**Permit
Application**

**Addendum
12/21/16**

**Re: Sundance West Surface Waste Management Facility [530.06.01]
Addendum No. 1 to Application for Permit**

Gordon Environmental, Inc. Consulting Engineers			2713 S. Camino del Pueblo Bernalillo, New Mexico, USA Phone: 505-867-6990 Fax: 505-867-6991
DATE: 12/20/2016	CAD: 250' RADIUS.dwg	PROJECT #: 530.06.01	
DRAWN BY: DMI	REVIEWED BY: CWF	FIGURE II.3.1	
APPROVED BY: IKG	gk@gordoneirromental.com

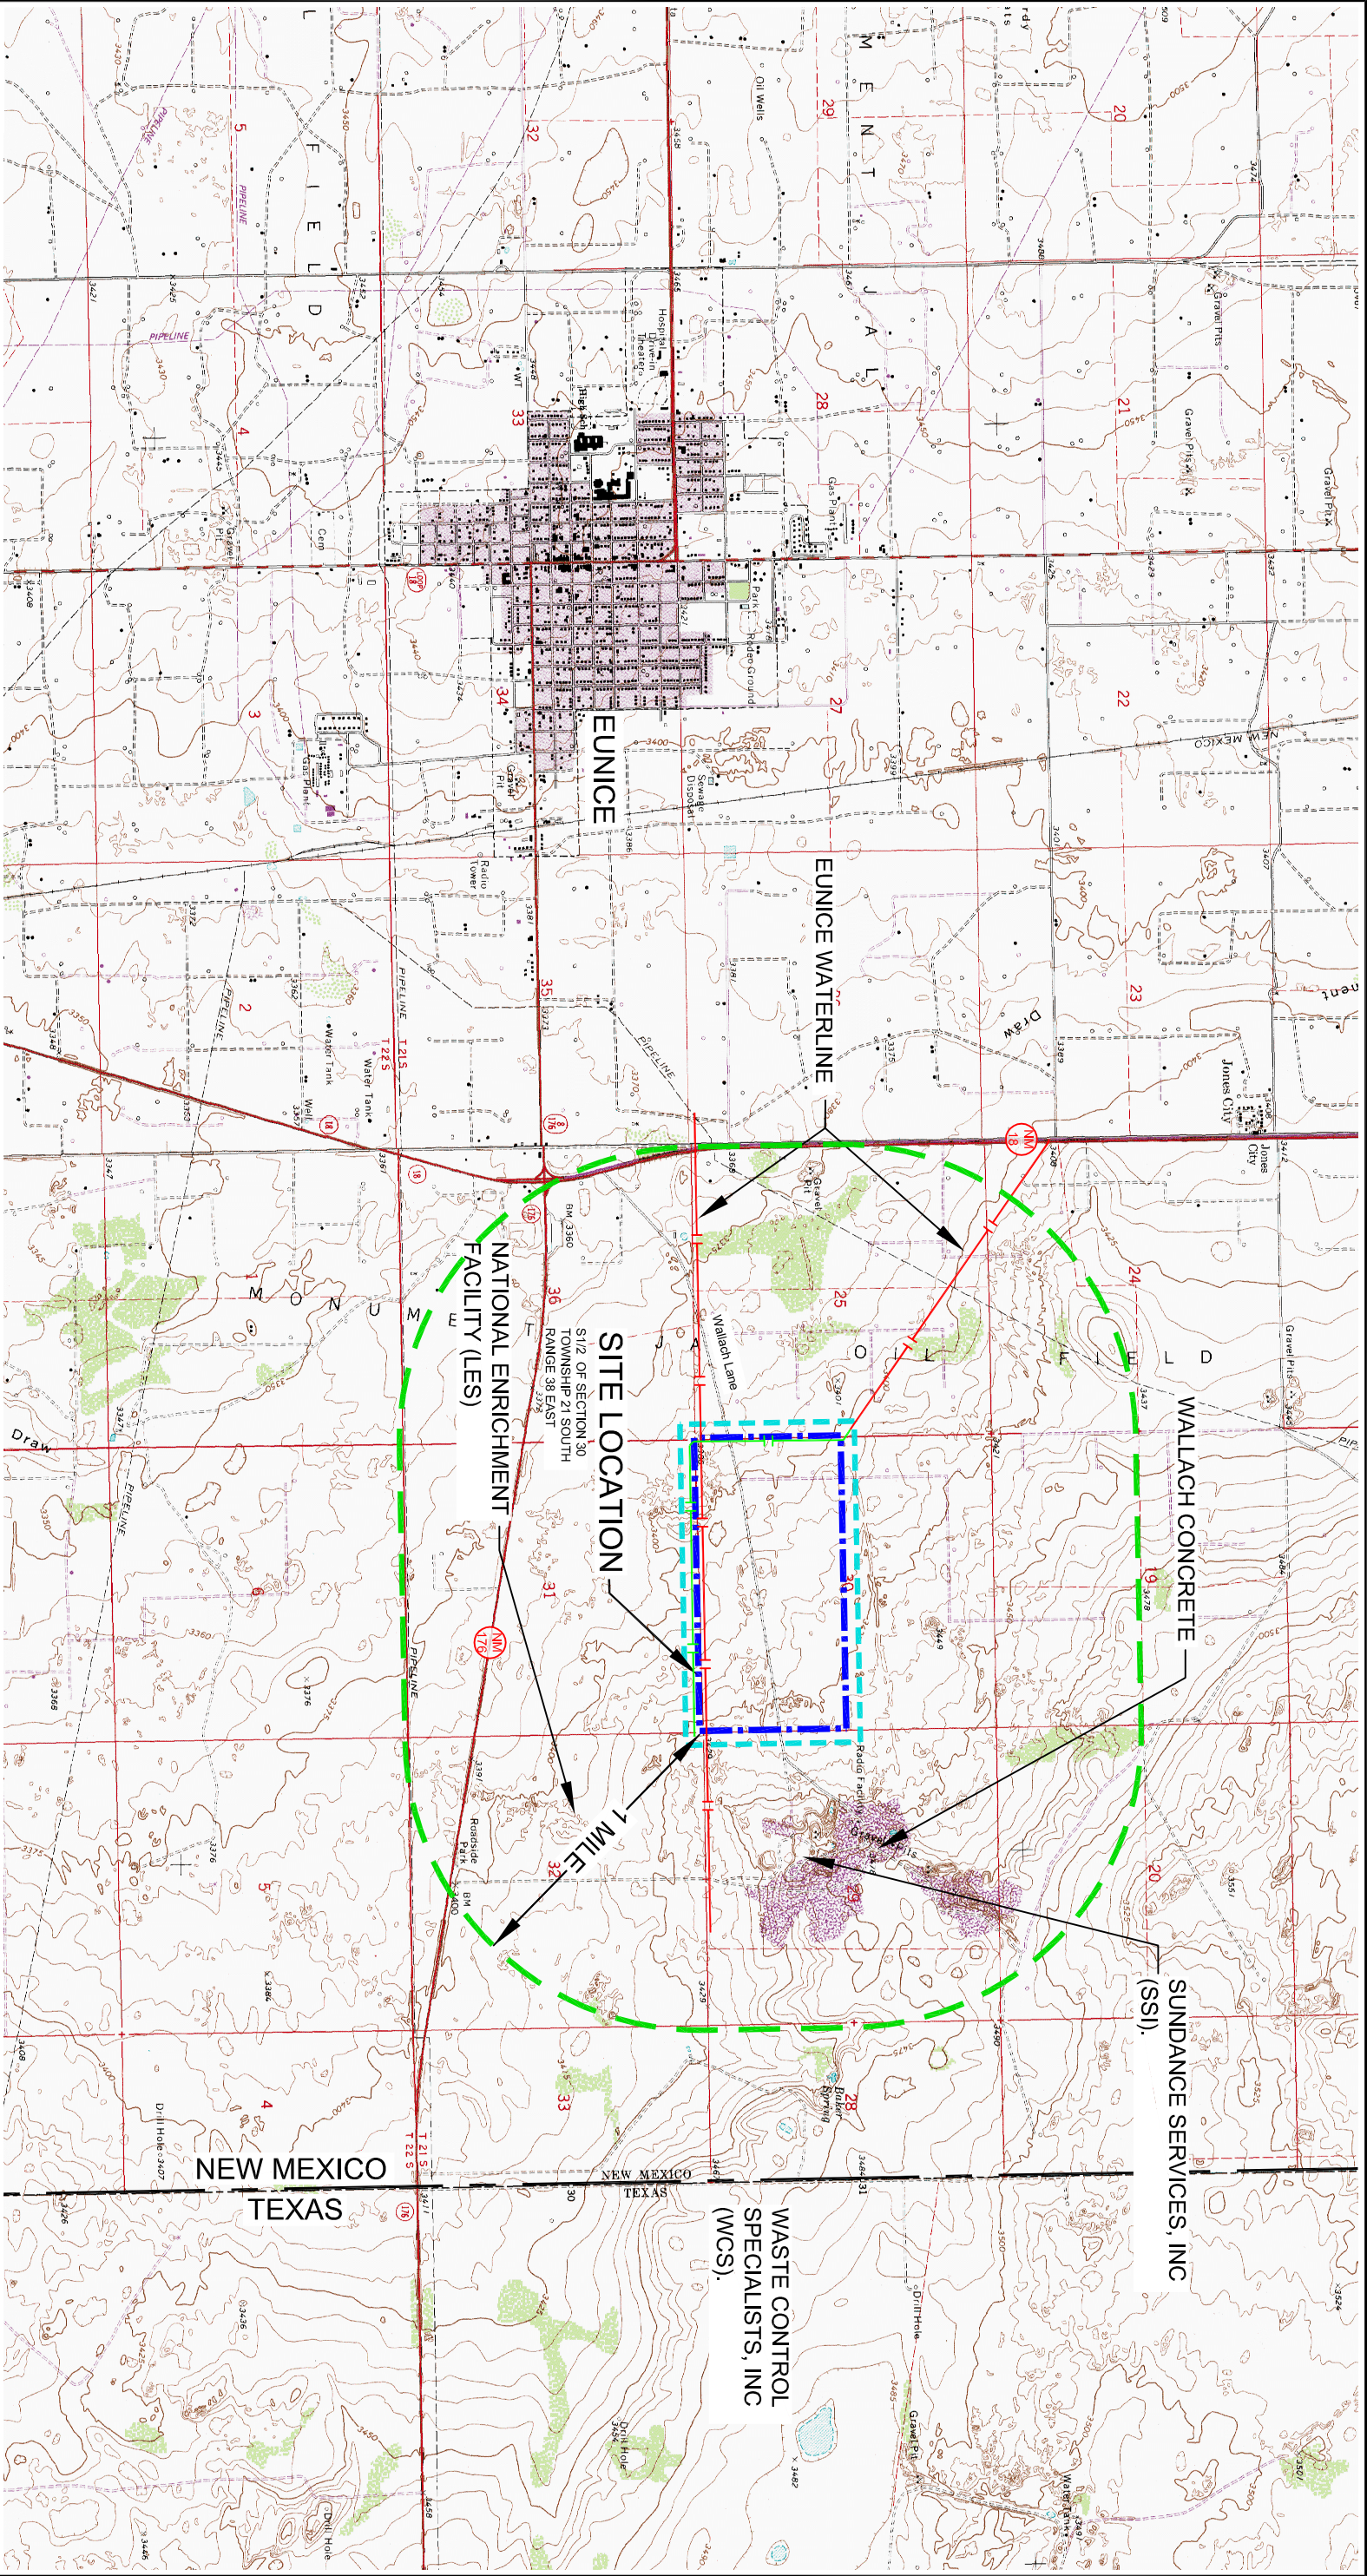
1. The “radius of exposure” discussed in the Hydrogen Sulfide Prevention and Contingency Plan needs to be included on a map.

Response: We have updated the text page II.3-7 of Volume II, Section 3 – Hydrogen Sulfide Prevention and Contingency Plan (**Attachment 1**). The RP-55 limit of 30 ppm will result in a radius of exposure (ROE) of 250 ft from the point of release (assuming a release rate of 100 SCFH on Figure C-2 of RP-55). Potential points-of-release are most likely to include the jet-out, the oil-water separators, or the produced water load out; however, in order to be conservative, we have identified an ROE of 250 ft from the property boundary, and this ROE is depicted on the updated Figure II.3.1 (**Attachment 2**). Please replace page II.3-7 and Figure II.3.1 of the Hydrogen Sulfide Prevention and Contingency Plan (Volume II, Section 3) with the updated versions, attached.

Additionally, this H₂S monitoring program is intended to demonstrate compliance with 19.15.36.8.C.(8) NMAC (Surface Waste Management), and the requirements of 19.15.11 NMAC (Hydrogen Sulfide Gas), as well as, other permit conditions that may apply to this Facility. Should monitoring results identify unexpected concentrations of H₂S in excess of 30 ppm (RP-55 limit) in a public area, the requirements of 19.15.11.8.C NMAC will be implemented and this Plan, developed specifically to be responsive to 19.15.11.9 NMAC, will be implemented as required with proper notification. The RP-55 limit of 30 ppm will result in a radius of exposure (ROE) of 250 ft from the point of release (assuming a release rate of 100 SCFH on Figure C-2 of RP-55). Potential points-of-release are most likely to include: the Jet-out, the oil-water separators, or the produced water load out; however, in order to be conservative we have identified an ROE of 250 ft from the property boundary. This ROE is depicted on **Figure II.3.1**, and there are no “public areas” or “public roads” (per 19.15.11.7(I) and (J) NMAC) within this ROE.
